**RE: Defect Information Report – Supplemental Report No. 1
12V-235, FL-551B, Western Star Battery Disconnect Switch Power Cable Routing
Dealer Notice**

June 2012
FL551AB
NHTSA #09V-226 and #12V-235
Transport Canada #09-169 and #12-168
REVISED NOTICE

Subject: Western Star Battery Disconnect Switch Power Cable Routing

Models Affected: Specific Western Star 4900 standard cab height vehicles manufactured November 10, 2008, through May 7, 2009, with a Detroit Diesel DD15 engine and a battery disconnect switch inside the cab.

Fig. 1, Incorrect Cable Installation

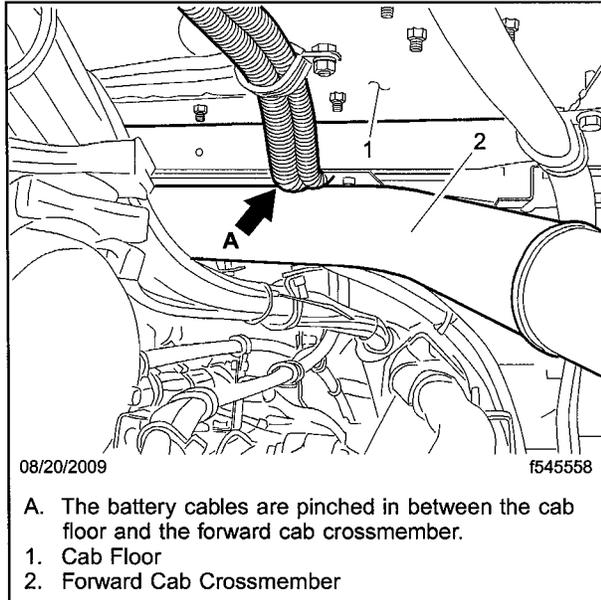
A new forward cab crossmember design reduced the clearance for cab-mounted battery disconnect switch power cables on standard cab height vehicles. During cab articulation, new crossmember may pinch the power cables against the cab and may cause the cables to short circuit, resulting in a possible vehicle fire and injury to the occupants.

2. Shut down the engine, apply the parking brake, and chock the tires.
3. Disconnect the batteries at the negative terminals, and open the hood.
4. Inspect the battery cables. On affected vehicles, the battery cable is routed on the inboard side of the windshield washer bottle. See **Fig. 1**.

8. Disconnect the cables all the way to the frontwall where the cable is bundled next to the magnetic switch.
9. Route the cables forward and to the outside of the windshield washer reservoir. Route the cables above the air horn, if equipped, and ensure they are routed above any hoses and wiring.

Fig. 2, Remove the P-Clamps

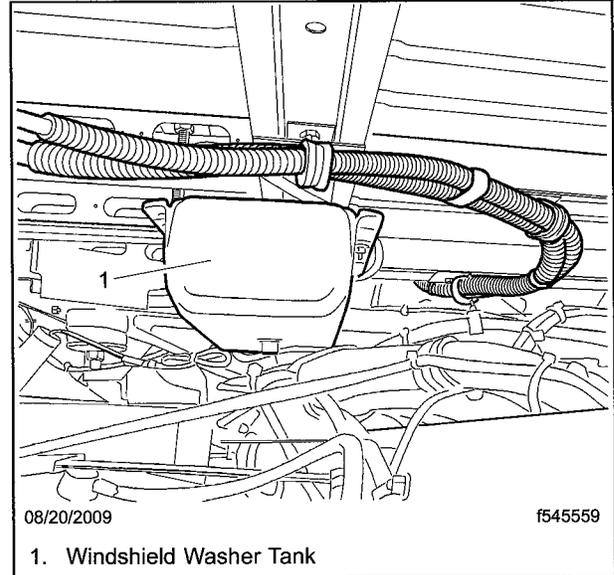
5. Remove the valence panel, located below the driver-side door.
6. From under the cab, disconnect the battery cables at the cab disconnect switch.
7. Remove the p-clamps and wire ties that secure the battery cables to the cab underbody, and remove the electrical tape that binds the two battery cables. See **Fig. 2**. Save the p-clamp assemblies, including all bolts, flatwashers, lockwashers, and nuts for installation.

Fig. 3, Air Horn Mounting

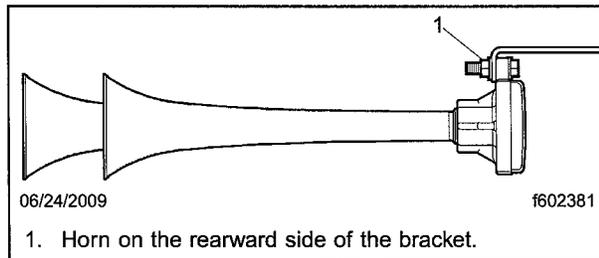
10. Ensure the air horn is mounted to the rearward side of the mounting bracket. See **Fig. 3**.
11. Connect the cables to the cab disconnect switch.
12. Secure the cables together with wire ties every 8 inches.

Fig. 4, Drilling the Hole in the Forward Cab Crossmember

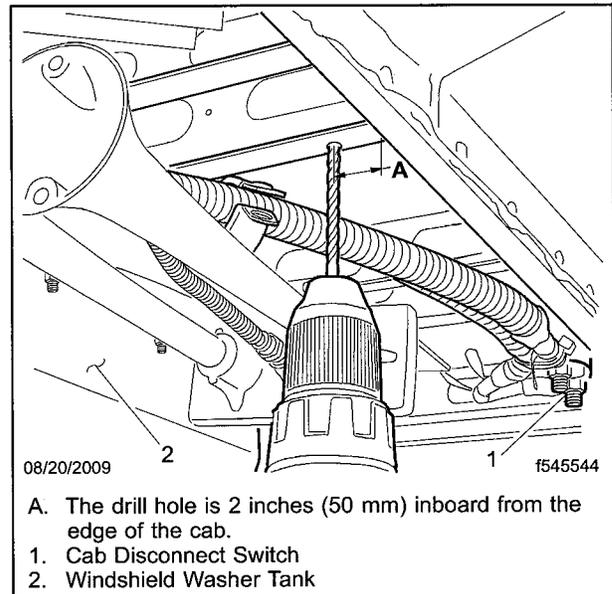
13. Drill a 1/4-inch (6-mm) hole on the forward cab crossmember, 2 inches (50 mm) inboard from the edge of the cab. Orient the hole on the rear edge of the crossmember. See **Fig. 4**.

Fig. 5, Battery Cable Mounting

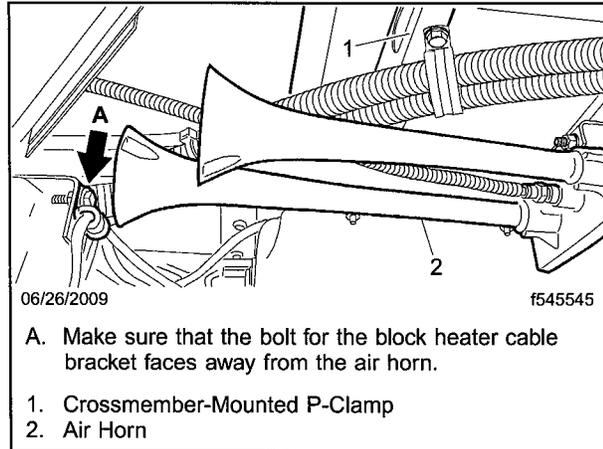
14. Attach one of the p-clamps removed earlier to the cable.
15. Secure the cable to the cab crossmember with a 1/4-20 bolt, flatwasher, lockwasher, and a nut. Tighten the nut 12 lbf·ft (16 N·m). See **Fig. 5**.

Fig. 6, P-Clamp Mounting Hole

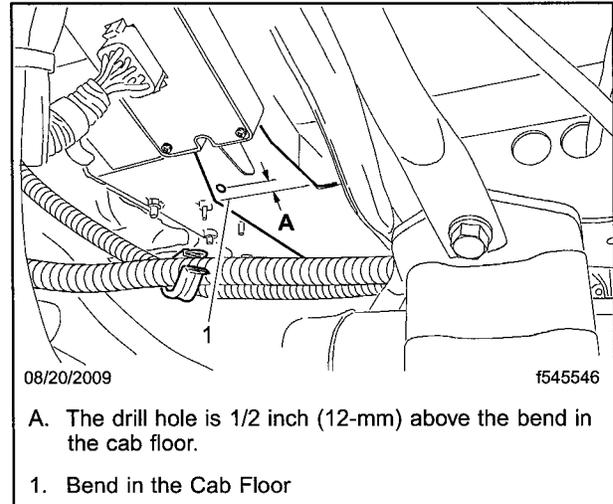
16. Drill another 1/4-inch (6-mm) hole 1/2 inch (12-mm) above the bend where the cab floor begins to angle upward to the frontwall. See **Fig. 6**.
17. Attach another p-clamp to the cable. Secure the p-clamp to the bend in the cab floor using a 1/4-20 bolt, flatwasher, lockwasher, and a nut. Tighten the nut 12 lbf-ft (16 N·m).
18. Install the remaining clamps on the edge of the engine tunnel making sure there is clearance between the engine and the cables. Tighten the p-clamp nuts 12 lbf-ft (16 N·m). See **Fig. 7**.
19. Route the cables up the engine tunnel by using wire ties to secure to existing wiring and brackets.
20. Bundle any slack in the cables to the harness on the frontwall of the vehicle where it was previously removed. Use wire ties to secure the bundle. See **Fig. 8**.
21. Connect the batteries.
